**SUBJECT: CEQA ADDENDUM FOR THE EAST SAN FERNANDO VALLEY LIGHT RAIL
TRANSIT PROJECT**

EAST SAN FERNANDO VALLEY TRANSIT CORRIDOR

Environmental Impact Report Addendum

Addendum to the Final Environmental Impact Study/Environmental Impact Report (FEIS/EIR)

Figure 1: Typical at Grade Center Platform Station

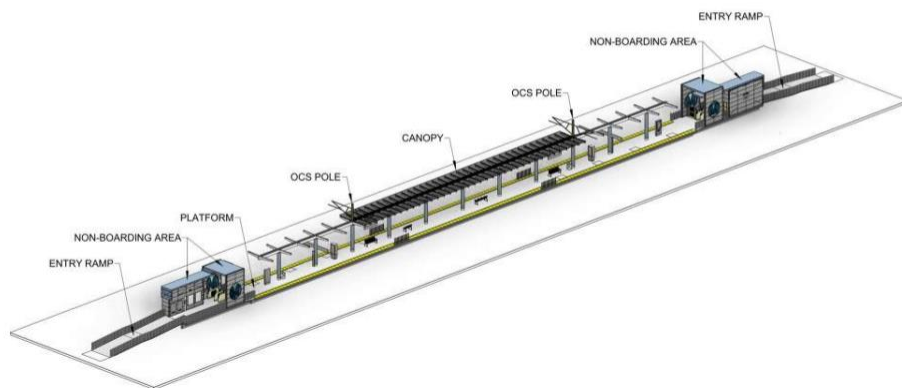
However, due to real estate right of way constraints, LACMTA has identified changes to the following four station locations shown in the Advanced Conceptual Plans dated March 15, 2019:

- < Van Nuys/San Fernando Station was relocated to the middle of Van Nuys Boulevard;
- < Arleta Station was moved from south of Arleta Avenue to north of Arleta Avenue;
- < Woodman Station was moved from south of Woodman Avenue to north of Woodman Avenue;
- < Van Nuys Metro G (Orange) Line Station was relocated to the middle of Van Nuys Boulevard.

All stations, except the Van Nuys/San Fernando, Van Nuys/Metrolink, and Metro G (Orange) Line stations, now include an underground room for electrical, mechanical and systems equipment, due to recent updates to the Metro Rail Design Criteria (MRDC) and Architectural Standard Drawings.

Figure 3: TPSS Site 9 and Nearby Noise-Sensitive Receiver Clusters

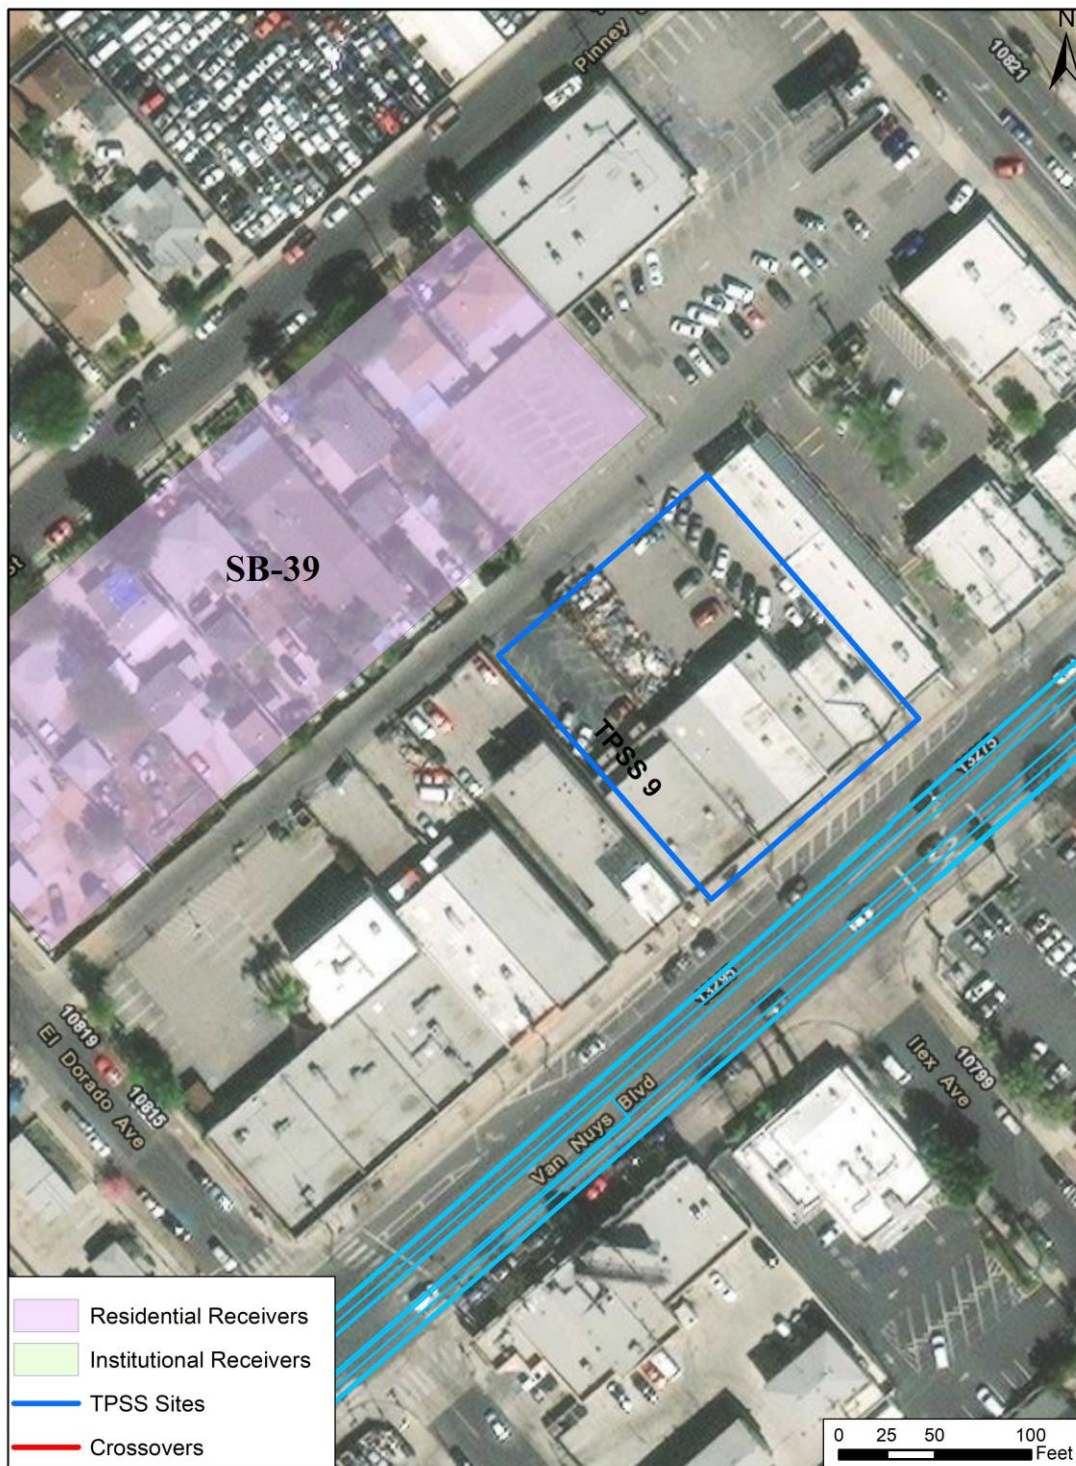
39 adjacent to TPSS Site 9 (see **Appendix F, Figure 1** and **Figure 2**). Receiver Cluster ID SB-7a represents 5 multi-family residential buildings with approximately 18 total residential units. The closest building is approximately 34 feet to the west of TPSS 5. Noise impacts are predicted at all of the buildings in this cluster and at Receiver Cluster SB-7b to the northwest. Receiver cluster ID SB-39 represents a cluster of single-family residences located on Pinney Street. The closest building is approximately 41 feet west of the TPSS site. Noise impact is predicted at residences within 135 feet of the TPSS unit.

Full property acquisition is also required for TPSS 9 for several buildings on Van Nuys Boulevard between El Dorado Road and San Fernando Road. The existing buildings form a continuous façade that significantly reduces the noise levels at the sensitive receiver cluster ID SB-39, which is set back one row off of Van Nuys Boulevard. The TPSS and other project facilities located at this site would not provide similar noise reduction as the existing buildings, and the removal of the buildings would result in an increase in noise levels above the noise impact threshold. Noise mitigation would be included in the TPSS site design to account for the increase in traffic noise levels from removing the buildings.
